THE CITY OF SAN DIEGO

Report to the Planning Commission

DATE ISSUED: January 2, 2025 REPORT NO. PC-25-007

SUBJECT: Garcia Residence, 812 Havenhurst Point, Coastal Development Permit and Site Development Permit, Process Three Decision Appeal

Figure 5 - 1st floor and 2nd floor overlay

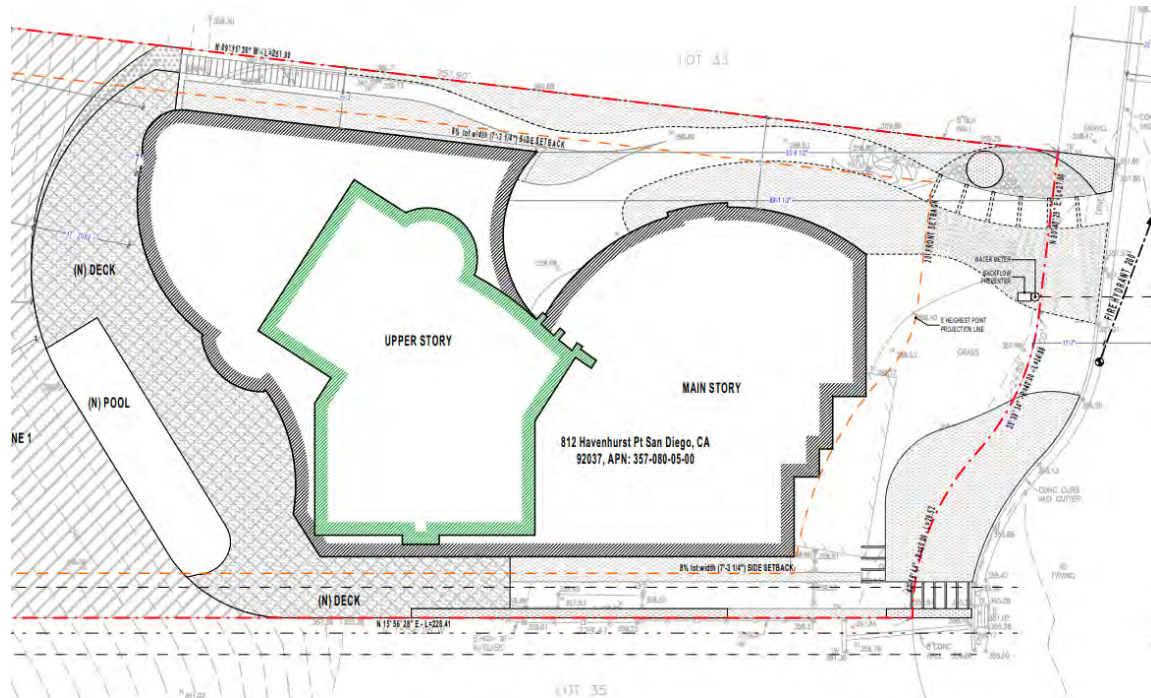
Appeal Issue #1: *The proposed plan is massively out of scale and character for our neighborhood.*

1. *The following numbers are from the plans that are included in the City report to the hearing officer for this construction:*
 - *The living space is 9,394 sq. Ft.*

- *There are three levels of decks for a total of 3,651 sq. ft.*
2. *The average home size in the Muirlands Point development is 3,095 sq. Ft.*
3. *My house is about 1750 sq. ft. and including the detached garage and structure is less than 3,000 sq. ft.*

Staff Analysis: As described previously, the project conforms to the 24-foot height limit to the commencement of the angled plane which extends to the overall 30-foot height limit as shown on the applicant’s development plans (Attachment 8). By proposing a structure that has a height of 27 feet as measured in accordance with technical bulletin BLDG-5-4, Determination of Building Height in the Coastal Height Limitation Overlay Zone the project conforms to the overall coastal building height limit of 30 feet. In accordance with this recommendation, the proposed project conforms to the angled plane regulations previously described and steps back the second floor from the first

floor. The second story is setback approximately 23 feet from the front façade of the first floor adjacent to Havenhurst Point. The second story is located at the center rear of the first-floor footprint, minimizing the visual impact of the second story, as shown in the figure below. By stepping back the second floor the proposed project maintains a linear consistency with the adjacent single-story structures and articulates the bulk of the streetside front facade.

Figure 7- Existing building footprint Overlay (Applicant provided exhibit)

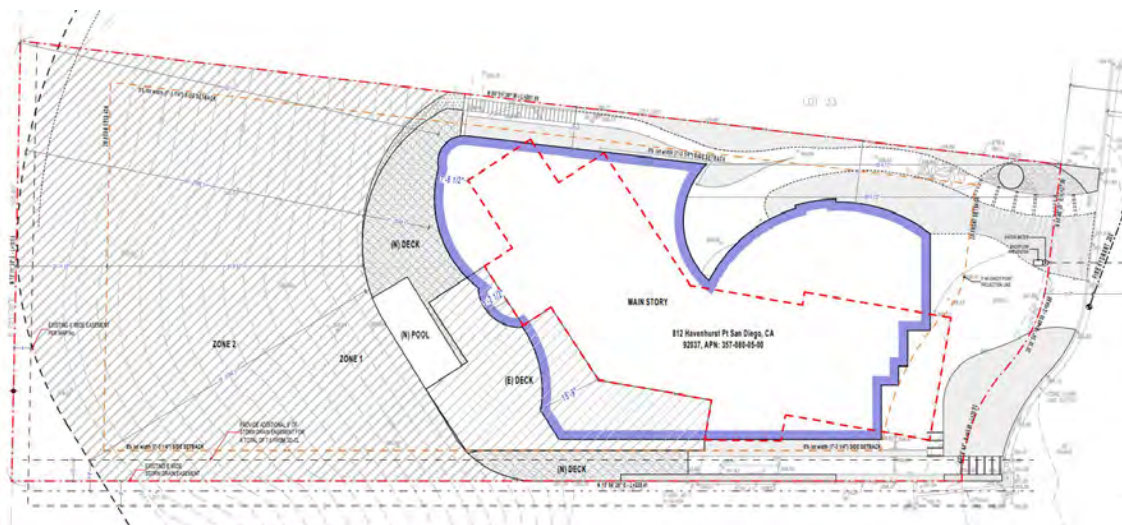
- 2. The proposed property is extended more than 30 feet down the canyon from its current limit on the north side. As shown in pictures on the next pages, this goes into the natural vegetations in the canyon. In addition, the brush management plan shows another 30 feet beyond the construction zone where at least 50% of the plants need to be cut down to 6 inches. The remaining 50% shall be pruned to reduce fuel loading in accordance with the landscape standards. This is nothing short of destroying the designated and protected Open Space as declared by the City of San Diego.*

- 4. The mandate of the designated Open Space Canyon is also to preserve and protect the open space values. As I have shown in the pictures on the next pages, the proposed structure destroys the open canyon view that I have enjoyed for over 27 years or so. It will have a similar impact on a lot of neighbors that have rejected this plan, and in general, anyone that lives around this canyon. Why is the city allowing a newly built structure and three levels of decks (that add up to a total of 3,651 sq. ft.) to go so far into a protected open-space designated canyon?*

Regarding the extension of the proposed structure beyond the existing footprint, Figure 7 below is an overlay of the existing building footprint and the proposed footprint of the building envelope. The figure shows that the proposed footprint extends less than 10 feet further down the slope at the northeast corner of the existing building footprint. The proposed exterior decks and roof overhangs extend approximately an additional 10 to 16 feet beyond the building envelope footprint and are stepped back from the lower levels to reduce the bulk and scale of the structure. Although the proposed structure, overhangs and decks extend further down the slope of the hillside the development is contained within previously disturbed hillside as shown in Figure 3 (Page 11) of the BTR dated April 2024, prepared by Leopold Biological Services (Attachment 9) as shown in Figure 6 above.

As described above the extension of the proposed structure beyond the existing footprint, Figure 7 above, illustrates that the proposed footprint extends less than 10 feet further down the slope at the northeast corner of the existing building footprint. The proposed exterior decks and roof overhangs extend approximately an additional 10 to 16 feet beyond the building envelope footprint and are stepped back from the lower levels to reduce the bulk and scale of the structure. By stepping back
